PIPING DESIGN

Functional Design, Qualification, and IST of Pumps, Valves, and Dynamic Restraints

ADDITIONAL MECHANICAL ENGINEERING TOPICS

Figure D.1—Fractional cycles to obtain one equipment maximum peak cycle

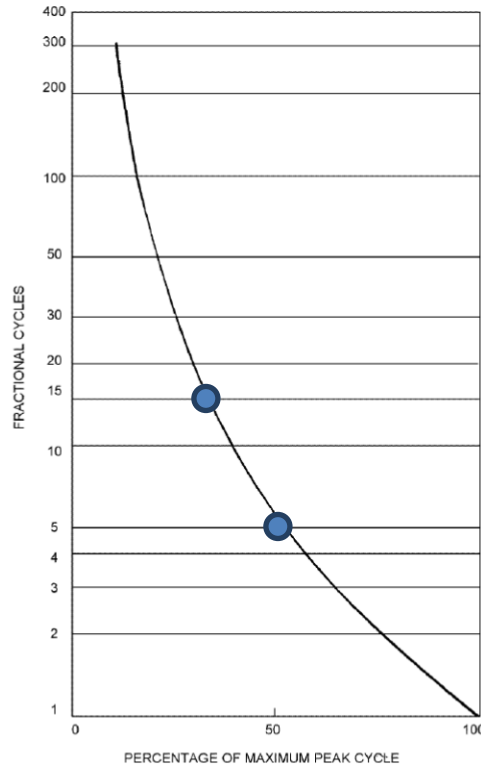
3-30: Section 3.10.1.3 states “With the elimination of OBE, analysis checks for fatigue effects can be performed at a fraction of the SSE (such as 50 cycles at one-half of the SSE peak amplitude, or 150 cycles at one-third of the SSE peak amplitude).” How were these numbers of

cycles selected? They appear to be different from those listed in Sections 3.9.2.2.3 and 3.7.3.1, as well as SRP 3.10.

When half SSE is applied for the fraction of an SSE, 5 fractional cycles are needed to have an equivalent fatigue effect corresponding to one SSE (Refer to Figure D.1 in Annex D of IEEE 344, below). Since one SSE event requires 10 maximum stress cycles, a total of 50 cycles (5 x 10) shall be applied to the analysis.

In the case of applying one-third SSE for the fraction of SSE, 15 fractional cycles are needed to have an equivalent fatigue effect corresponding to 1 SSE (Refer to Figure D.1 in Annex D of IEEE 344). As one SSE event requires 10 maximum stress cycles, a total of 150 cycles (15 x 10) shall be applied to the analysis.

In conclusion, 20 full cycles appeared in Section 3.9.2.2.3 and 3.7.3.12 is for two SSE events; whereas, 50 cycles at one-half of the SSE peak amplitude or 150 cycles at one-third of the SSE peak amplitude in Section 3.10.1.3 is for one SSE event with fractional cycles. Therefore, since the cycles in Section 3.9.2.2.3 or 3.7.3.1.2 have a different basis for the number of events than those in Section 3.10.1.3, it is not necessary to change the number of cycles, nor the associated description pertaining to this question.
